# **What are you doing? An assault on semi-arid lands**

**Arid Lands Environment Centre's submission on the Draft Western  
Davenport Water Allocation Plan**

**Sunday 14 May 2023**

*Figure 26. Modelled salinity (expressed as electrical conductivity,  $\mu\text{S}/\text{cm}$ ) of the saline layer at the top of the aquifer (Scenario 1, No Recycling), assuming  $c_0 = c_G$ . It is estimated using Equation 12.*

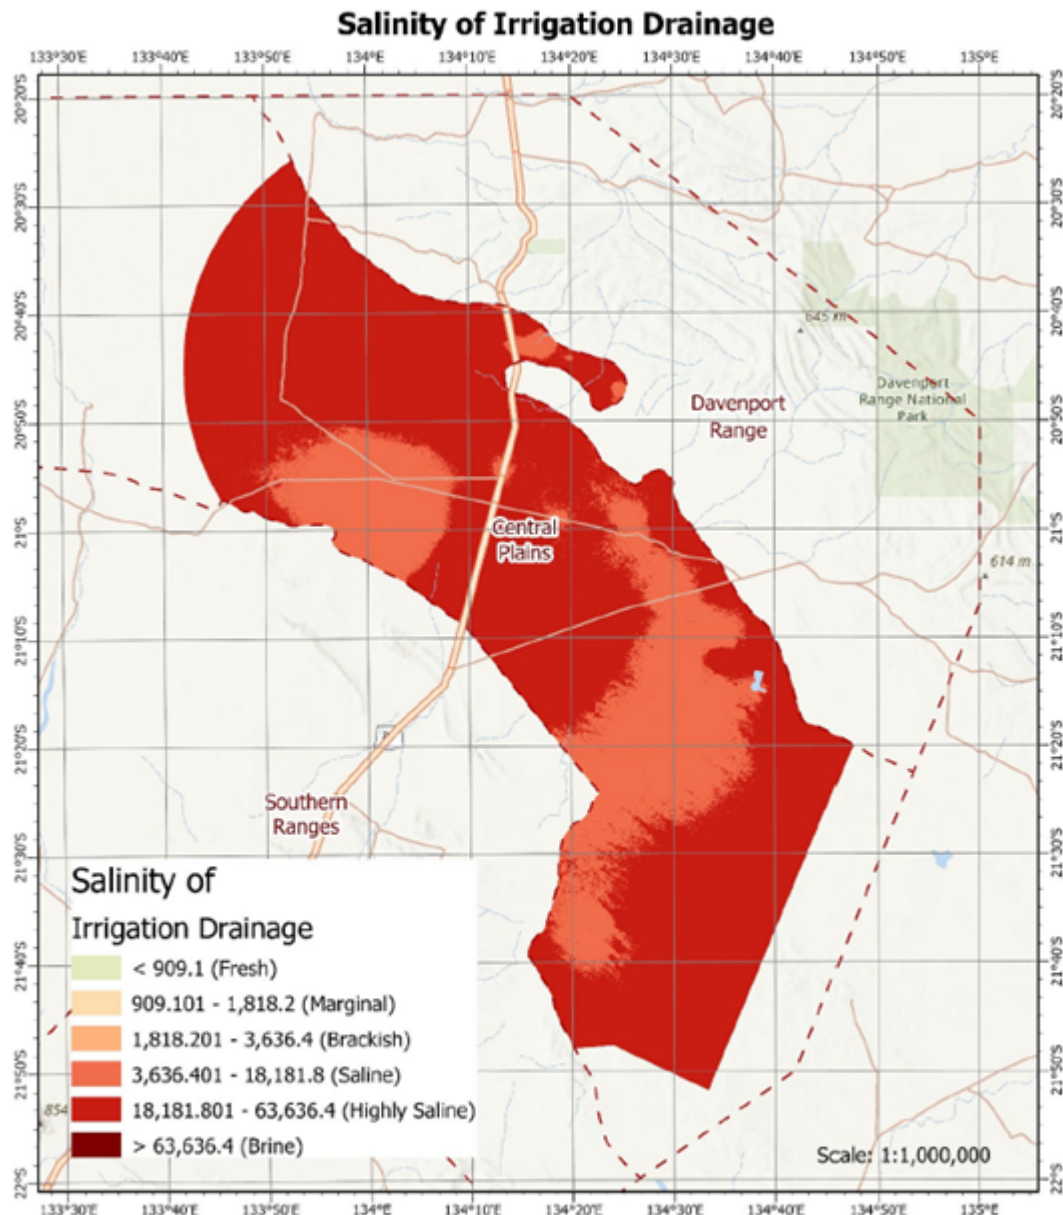
103. Cooke and Keane also highlight (p iv) that there is a lack of knowledge of the salinity of soil water within the unsaturated zone and that this is an even greater concern. There are no estimates of this parameter within the Western Davenport Water Control District, but studies in Ti Tree Basin and at Rocky Hill show that some areas contain very large salt stores that could be a threat to the underlying groundwater system and to the sustainability of irrigated agriculture. It identifies that further work is needed to understand the reason for the large degree of variation in soil salinity. If the soil salinity is high, the salinity increases due to irrigated agriculture could be much greater than predicted in this report.

104. Increased salinity of irrigation water not only impacts crop yield and aquifer salinity, but also changes the permeability and structure of the soil itself: 'Moreover, soil sodicity often increases with increasing irrigation-water salinity and this can lead to **decreasing soil permeability and breakdown of soil structure** (Quirk and Schofield 1955).' (Source: Foster et al., 2018) (emphasis added)<sup>52</sup>

105. Australia has long ranked among the top countries globally for extent of area impacted by secondary salinisation, and the impacted area has risen significantly over the past decades (Niknam and McComb, 2000).<sup>53</sup> It is generally accepted that the cause for the greatest proportion of this secondary salinisation is the widespread removal of native vegetation for perennial crops. This process will be repeated in the Western Davenport region; it would be irresponsible to add more than 3500 ha by way of the Singleton development,<sup>54</sup> which receives a sizable allocation under this plan, to Australia's burgeoning area impacted by secondary salinisation.

## Appendix A - Data from climate services for Agriculture medium emissions scenario (Ali Curung)<sup>59</sup>

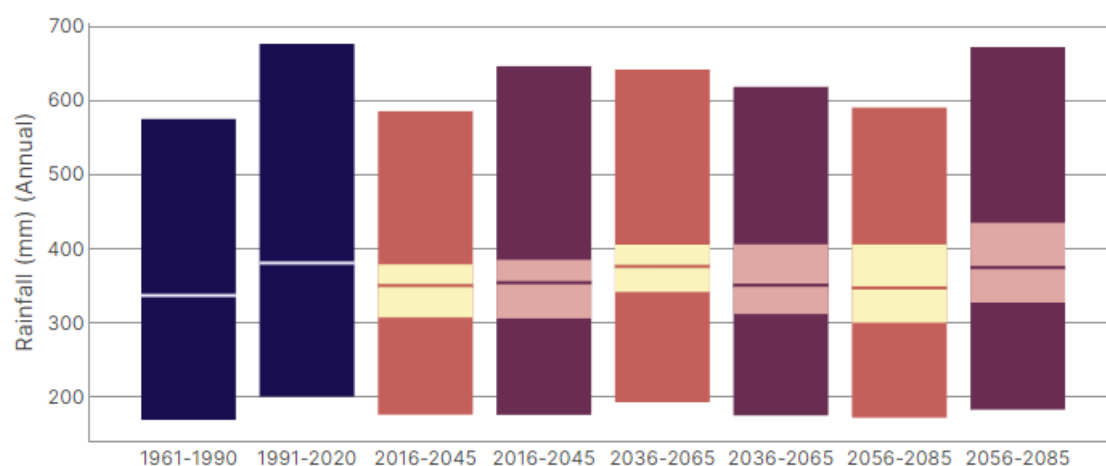
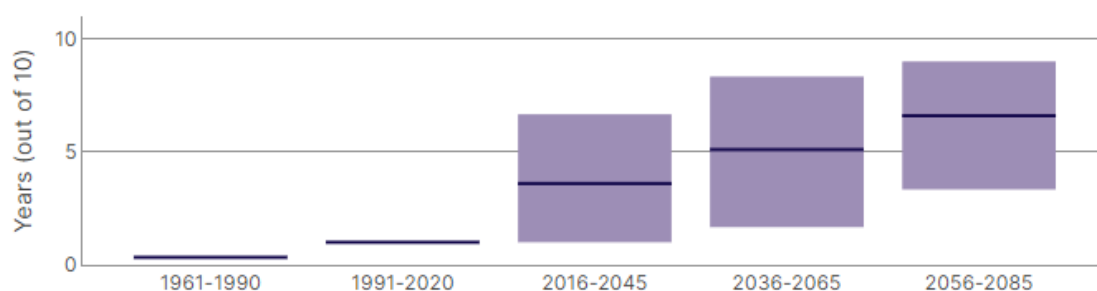
39. We note the climate services for agriculture<sup>22</sup> rainfall projections under different emissions do not give any assurance of a wetter climate, and not wetter than 1991-2020, with declines within the range of possibilities (See Appendix A). It does however provide almost absolute certainty that the climate will become much hotter. We contend that the regional groundwater dependent ecosystems will be key refuges for overall ecosystem resilience in the dry and extremely hot periods we inevitably face.
